# Amtranet Limited (New Buildings 2)

14 December 2023

## Structural Inspection Report

Author: Md. Latifur Rahman Siddique and Md. Jahidul Islam

### Observation-1: Mismatch between provided drawing and on-site condition (Building-3)

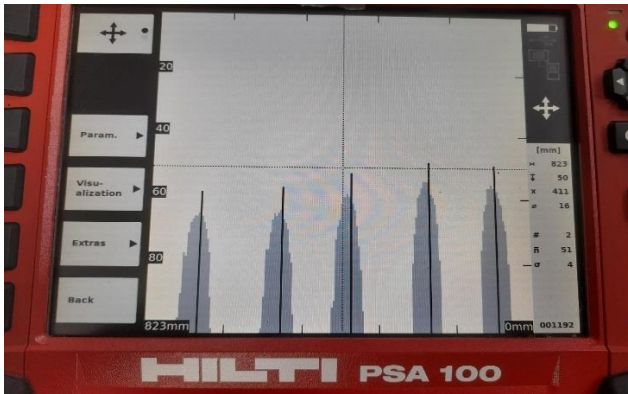
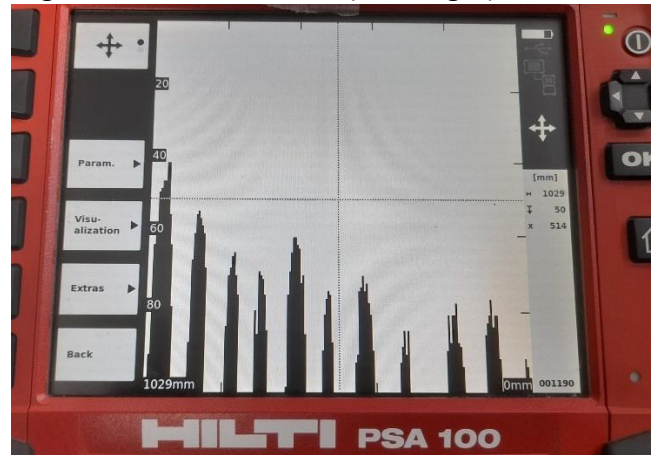
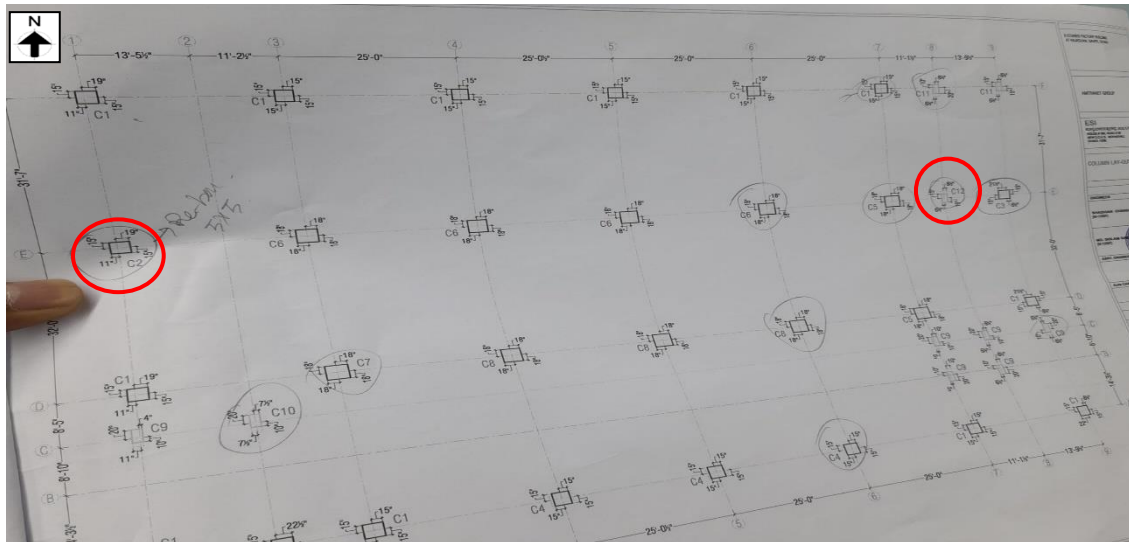
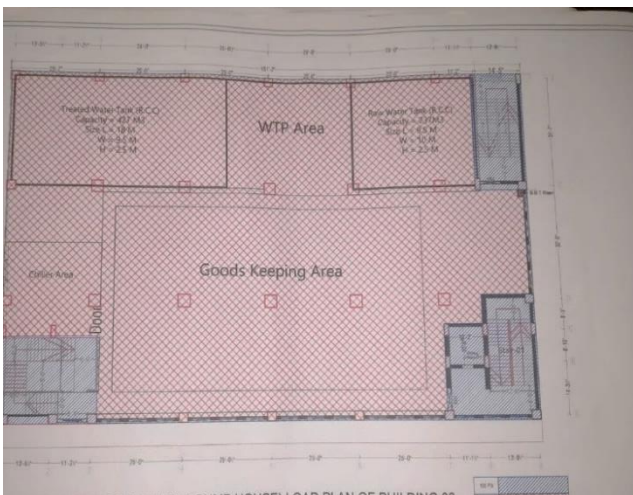
Column C2 exposed rebar at roof

Column C2 re-bar profile scan at 1<sup>st</sup> floor

Column C2; less numbers of re-bar observed

Column C12; less numbers of re-bar observed

### Column Layout; Rebar profile mismatch at C2 (Grid-1-E) and C12 (Grid-8-E)

**Description:** During the inspection, column type C2 & C12 re-bar information mismatches observed with the provided drawing and on-site condition. The building engineer is required to survey the full structure and prepare accurate as-built drawings accordingly.

#### Observation-4: Possibility of Vertical Extension. (Building-3)

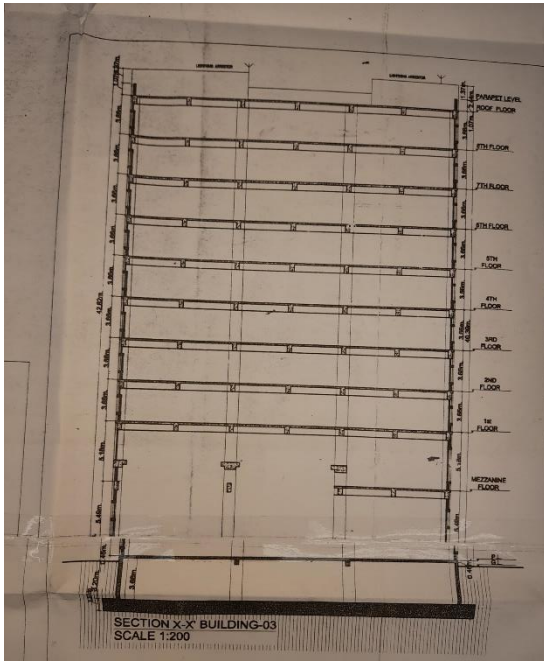
**Description:** The building permission layout is for nine storied with mezzanine at ground floor approved from Savar Pouroshova (Local Authority) dated 19-April-2017. For the structural changes and adding new structures the factory had taken revised approval on 16th July 2023 for the Building-3. There are extended column rebar at roof. The building engineer is required to check the structure for lateral loading considering full proposed nine storied and submit to RSC for review and submit to RSC for further review.

**Observation-8:** Trolley impact on Column. (Building-3)

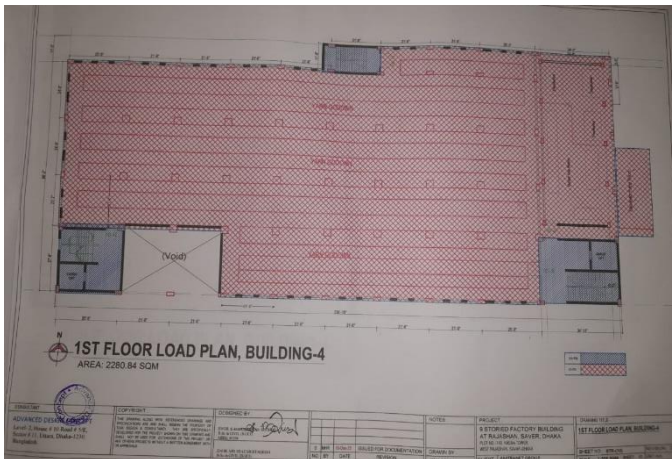
**Description:** RC Column was found damaged due to the impact with trolley. The engineer is required to investigate the damage and suggest a remedial action as well as provide suggestion to prevent such damages in future. Factory is required to follow the suggestion of the engineer for remedial actions.

**Observation-10:** Load plan does not comply with BNBC requirement. (Building-4)

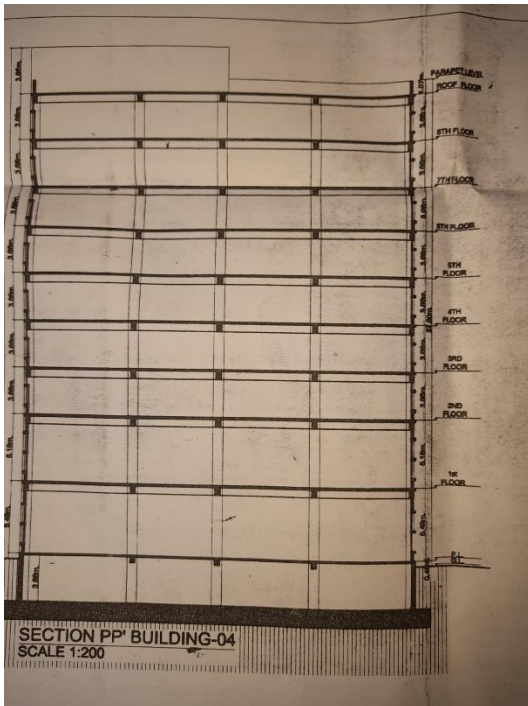
**Description:** Factory has prepared a load plan. The live load has been considered 3 kPa for the storage area on 1<sup>st</sup> floor instead of 6 kPa as per BNBC. Also, storage loading was found in some locations the 2<sup>nd</sup> floor. Factory is required to revise the load plan as per the requirement of BNBC.
